STATE OF WASHINGTON
DEPARTMENT OF ECOLOGY

July 12, 2017

Re: Further Action at the following Site:

This opinion letter provides comments Enco's *Independent Remedial Cleanup Action Work Plan*, dated May 23, 2017. Excavation of contaminated soils and installation of six additional monitoring wells is proposed. A Site description and selected figures (1-4) are included in **Enclosure A**.

Figure 4

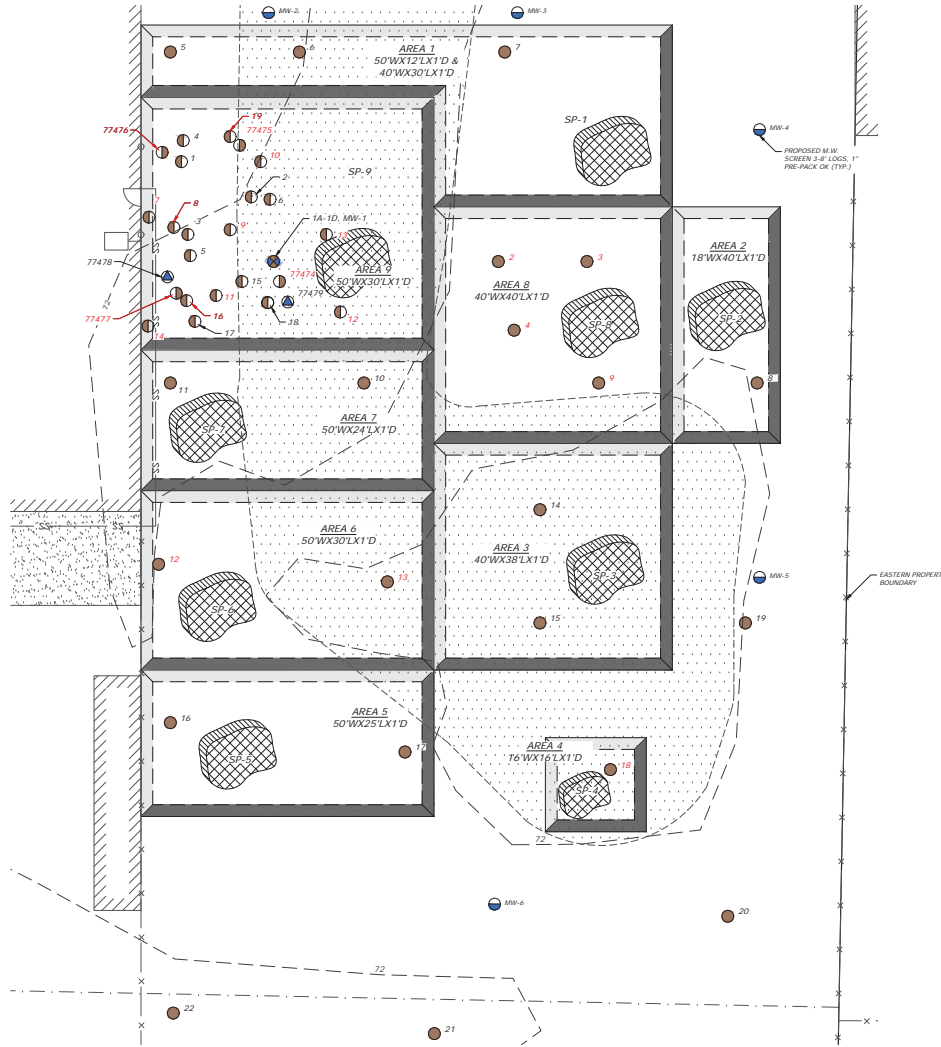
9. Where field screening or visual observations indicate contamination is likely to be present outside of Area 9, soil sampling may need to be adjusted to a broader scope of COCs (e.g., similar to the list proposed for Area 9). If there is any question whether or not additional analytical results should be obtained at a given sample location, Ecology recommends collecting the additional data. If analytical data indicates that there may be uncertainty regarding whether or not a soil stockpile should be disposed of off-Property at an approved facility, Ecology suggests disposal of the soil stockpile at the off-Property facility.

- Did (or will) the City of Sumner require (or complete) a SEPA determination for the excavation as part of the grading permit?
- If the gravel apron is set aside prior to excavation, I recommend removing the shallowest estimate of emplaced thickness (~4"), and sampling the gravel pile for Site COCs in soil to demonstrate it is uncontaminated. However, if the gravel pile is incorporated into the stockpiles and sampling program shown on Figure 6, then no additional sampling is recommended.

- Based on the historical sampling data, I anticipate stockpiles for areas/cells 6, 7, 8, and 9, will require off-Site transport and disposal.
- The total cubic yards of excavation and disposal may exceed the original estimate, though it appears in the work plan this contingency is anticipated.
